RE: Percolation test results –**A518986**
Proposed SDA for Subdivision/ Two-lot
Tax Map: 28 Lots:51, 52

SUBJECT: F-04-091 – Twelve Hills, Section 3, Lot 52

RE: File Number: F-04-091
Title: Twelve Hills, Section 3, Lots 51 & 52

RE: F 04-91/Twelve Hills
Sec.3, Lots 51 & 52

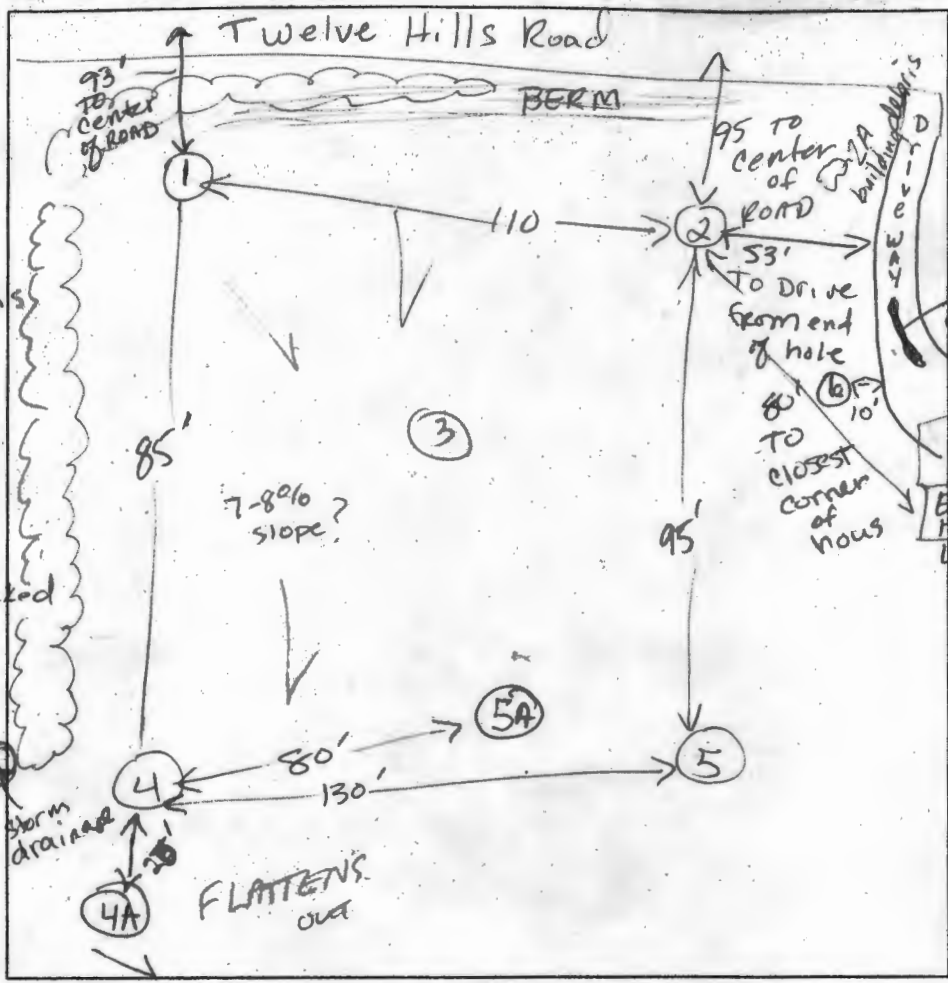
STOPPED
DIGGING
@ 12' OK

DATE	TEST #	DEPTH	START	BREAK 1" DROP	STOP 2" DROP	TIME OF 2nd INCH	P/F/H
7-14-03	(4)	6 1/2' / 12'v	9:13 ³⁴	9:23	9:31	8	P
	(1)	4 1/2' / 12'v	9:24 ³⁰	9:32 ²⁸	9:41	9	P
	(2)	7' M / 16'v	9:59	10:02	10:07	5	P
	(6)	Visual					F
	(5)	Visual	more Kx frags than @ 4				F
	(4A)	Visual	mottles @ 6 1/2' - water @ 13'				F
	(5A)	5 1/2' / 13'v	11:06	11:01	11:17	6	A/P
	(3)						P

REMARKS ADJUSTED LOT 51 SDA (5A) Well drained soils, expect H₂O to reach 11'
